Access Compliance Report

Public Rights-of-Way

(Curb Ramps)

Intersection ID: 27763	Main Street: BALLANTYNE_CROSSING_AV	Cross Street: BRICK_CHURCH_CT	Location:	N
ADA ID: A62BF407801F	Ramp Type: BlendTrans2	Initial Pass/Fail: Fail	Overall Compliance: No	Severity Score: 17.5
Codes/Mitigation Info/Possible Solution		Field Measurements/Component Compliance

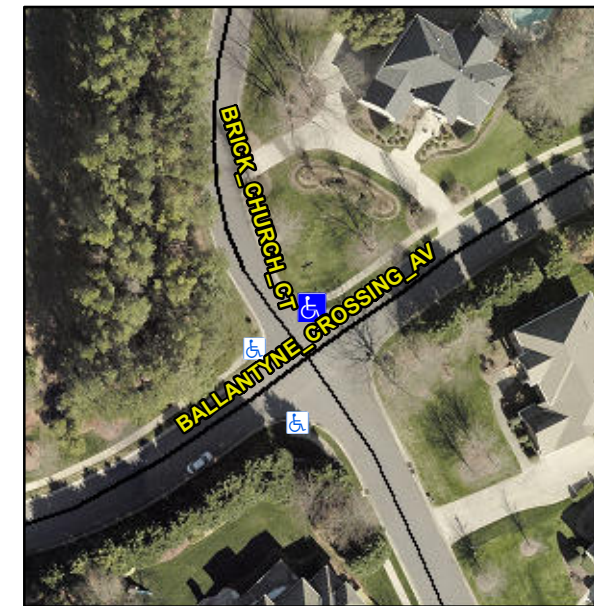
Not Found, R304.5.1

Compliance	Description	Data	Compliance	Description	Data
N/A	Ramp Length (in)	94.0	Yes	BlendTrans Slope (%)	4.4
No	Ramp Width (in)	34.0	Yes	BlendTrans XSlope (%)	2.0
N/A	Flare Type LT	N/A	N/A	Flare Type RT	N/A
N/A	Flare Slope LT (%)	N/A	N/A	Flare Slope RT (%)	N/A
N/A	Flare Traversable LT?	N/A	N/A	Flare Traversable RT?	N/A
N/A	Landing Length (in)	N/A	N/A	DWS Provided?	N/A
N/A	Landing Width (in)	N/A	N/A	DWS Contrast?	N/A
N/A	Landing Slope (%)	N/A	N/A	DWS Length (in)	N/A
N/A	Landing X Slope (%)	N/A	N/A	DWS Full Width?	N/A
N/A	Landing Curb? (Y/N)	N/A	N/A	DWS Offset (in)	N/A
N/A	Shared Landing?	N/A			
N/A	Gutter Ponding?	N/A	N/A	Gutter Slope (%)	N/A
N/A	Gutter Lip Ht (in)	N/A	N/A	Gutter X Slope (%)	N/A
N/A	Painted X Walk1?	No	N/A	Painted X Walk2?	No
	X Walk 1 Direction	To SW		X Walk 2 Direction	To SE
	X Walk 1 Width (in)	N/A		X Walk 2 Width (in)	N/A
	X Walk 1 Slope (%)	1.5		X Walk 2 Slope (%)	7.7
	X Walk 1 X Slope (%)	7.6		X Walk 2 X Slope (%)	1.1

N/A	Ramp inside XWalk1?	N/A	N/A	Ramp inside XWalk2?	N/A
	Road Slope (%)	7.3		Clear Space?	N/A
	Road X Slope (%)	5.6	N/A	Clear Space to XWalk (in)	N/A
N/A	Any Obstructions?	N/A	N/A	Storm Grate/Utility Hazard?	N/A
	Obstruction Type			Storm Grate/Utility Type	
		N/A			N/A
			Yes	Surface Condition? (G/P)	Good
			No	Curb Slope (%)	8.5

Remove & Replace Curb Ramp With Two New Directional Ramps or Equivalent.
